Affiliated to Federation Internationale Des Experts En Automobile				
AUTOMOTIVE ENGINEERING & MGT DIVISION		Ref : CS/SPF17023172/Gvb		
CONTRACT MANAGEMENT SECTION (SINGAPORE POLICE FORCE) 1 MOUNT PLEASANT ROAD BLK 8 OLD POLICE ACADEMYSINGAPORE 298333		Date : 06-12-2017		
		Code : SPF3

From: Veron Chen (LKKAUTO)
Sent: Monday, 11 December, 2017 3:25 PM
To: Perry HE (SPF) (Perry_HE@spf.gov.sg)
Cc: Wei Yea LIM (SPF) (LIM_Wei_Yea@spf.gov.sg); Kwee Huat TAN (SPF) (TAN_Kwee_Huat@spf.gov.sg); Kim Pang CHAY (SPF) (CHAY_Kim_Pang@spf.gov.sg)
Subject: RE: Appraisal Services for SPF vehicle at INDECO - HOMSPFETQ16000399 - QX329A
Attachments: PHOTOS.pdf; QX 329A.xlsx

Reference No.
MHA/SPF/2017/11-0029

AUTOMOBILE INSPECTION REPORT OF VEHICLE QX 329A

Description of affected area/required works (e.g. dented, cracked, grazed etc)

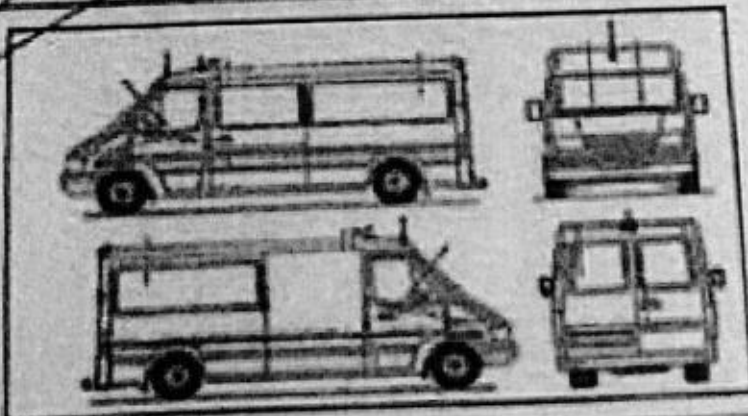
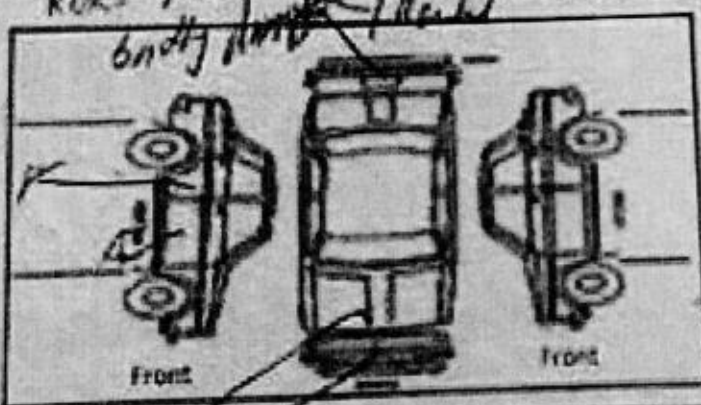
- ① Rear portion badly damaged and dented
- ② Right portion / front and rear door dented
- ③ front portion badly damaged / dented

Rear portion
badly dented

④ to do alignment
check
req
